**25 W MAIN ST DEVELOPMENT  
ADDENDUM 1 EXHIBIT**

E & W MAIN, S CARROLL, S PINCKNEY 2017  
PROJECT NO. 11429 SHEET NO.  
W-5

WATER PLAN AND PROFILE

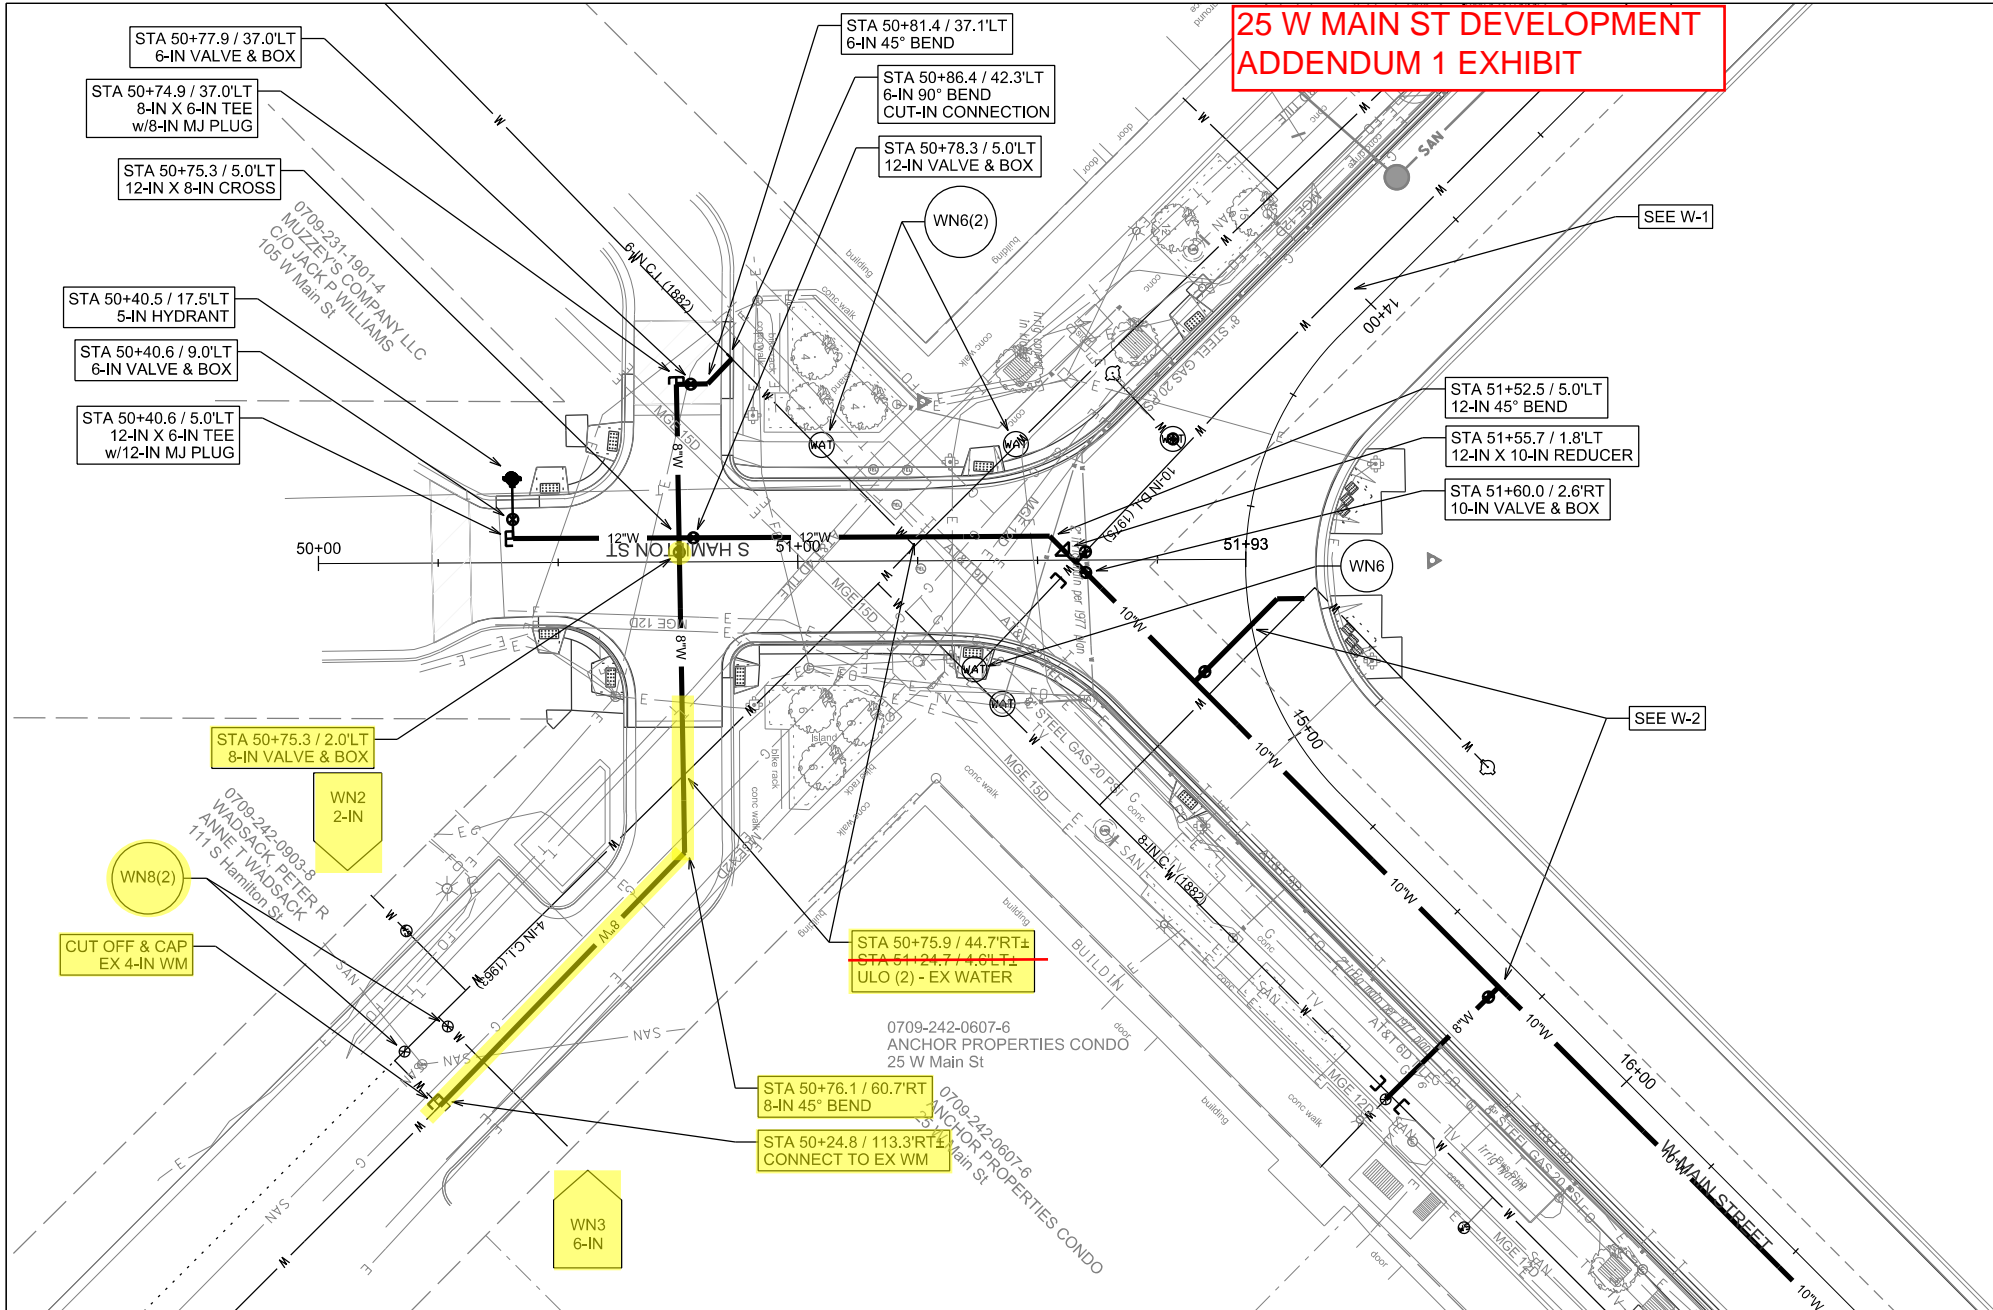
**Approx. related work to  
25 W Main development**
